Service Bulletin

Bulletin No.: 05500

Subject: 05500 — IGNITION DISTRIBUTOR SYSTEM CORROSION – INSPECT / REPLACE

Models: 2001-2003 CHEVROLET SILVERADO
2001-2003 GMC SIERRA
EQUIPPED WITH 4.3L V6 (RPO L35 - VIN W or RPO LU3 – VIN X) ENGINE

1580849

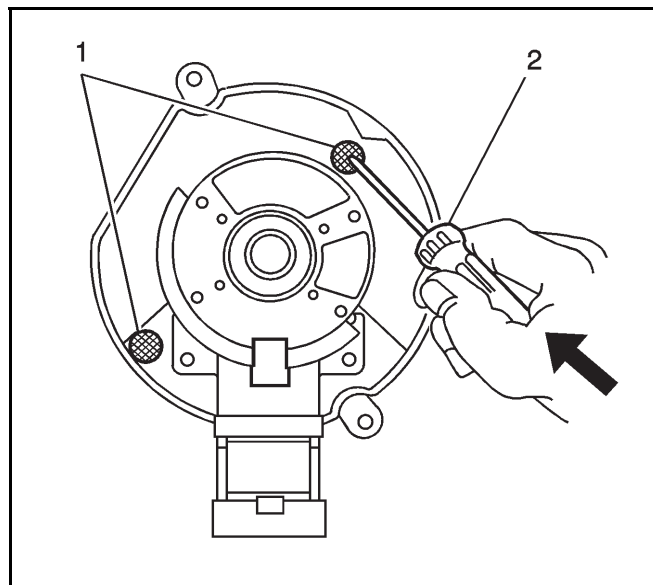
3. Remove the vent screens (1), located in the base of the distributor, by inserting a plastic-handled, long blade awl or pick (2) into each of the two airflow vent holes and popping out the screen. If there are no EIP vent screens in the airflow vent holes, check the vent holes for debris and clear as necessary before reassembling the distributor.
